Technical Bulletin / Safety Alert

Unique ID No : DES2017-TBSA-02 **Rev: 0**

Subject : Intake Flametrap Housing – Dimensional Tolerances

Figure 1.

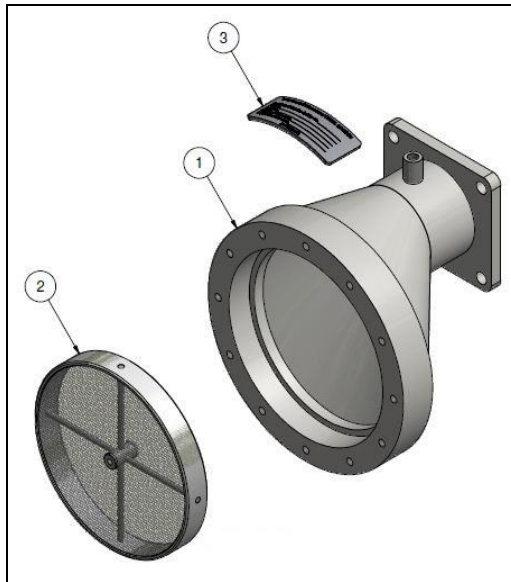
As per VLI’s previous TBSA in 2014 (DES-2014-TBSA – 03); VLI will only supply the Intake Flametrap Housing as an assembly as shown in Figure 1.

While individual Intake Flametrap Elements are still available separately, VLI recommends using complete assemblies as shown in Figure 1, to ensure 100% compliance with Design Registered Approval.
